Access Compliance Report

Public Rights-of-Way

(Curb Ramps)

ADA ID: RPRK211111141018 Ramp Type: Type 4 - Parallel Initial Pass/Fail: Fail Overall Compliance: No Severity Score: 2

Main Street: ZINNIA_ST Cross Street: GILLY_FLOWER_ST Location: W

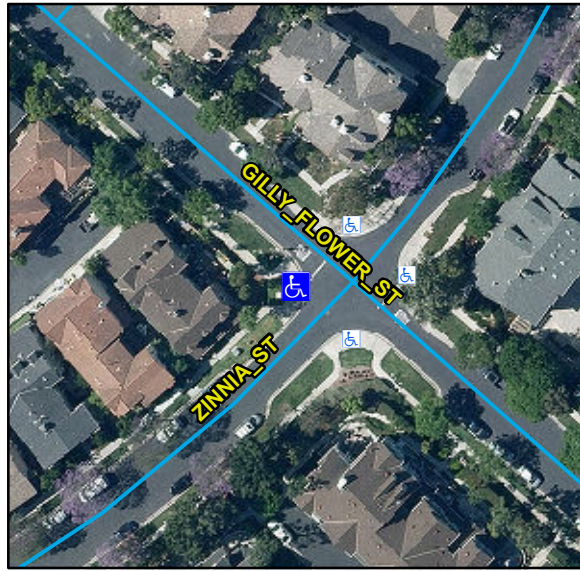
Compliance	Description	Data	Compliance	Description	Data
N/A	Ramp Length LT (in)	126	N/A	Ramp Length RT (in)	132
Yes	Ramp Width LT (in)	90	Yes	Ramp Width RT (in)	90
Yes	Ramp Run Slope LT (%)	4.6	Yes	Ramp Run Slope RT (%)	6.3
Yes	Ramp Cross Slope LT (%)	0.9	No	Ramp Cross Slope RT (%)	2.3
N/A	Landing Present	N/A	N/A	DWS Provided	N/A
N/A	Landing Length (in)	N/A	N/A	DWS Contrast	N/A
N/A	Landing Width (in)	N/A	N/A	DWS Length (in)	N/A
N/A	Landing Run Slope (%)	N/A	N/A	DWS Full Width	N/A
N/A	Landing Cross Slope (%)	N/A		DWS Offset Type	N/A
N/A	Landing Movement Obstructed?	N/A	N/A	DWS Offset Left (in)	N/A
	Landing Movement Type	N/A	N/A	DWS Offset Right (in)	N/A
N/A	Landing Shared	N/A			
N/A	Clear Space	Yes			
N/A	Clear Space To Crosswalk (in)	N/A			
N/A	Marked Crosswalk 1	No	N/A	Marked Crosswalk 2	No
	Crossing 1 Direction	SE		Crossing 2 Direction	NE
N/A	Marked Crosswalk 1 Width (in)	N/A		Marked Crosswalk 2 Width (in)	N/A

Remove & Replace Curb Ramp With Two New Directional Ramps or Equivalent.
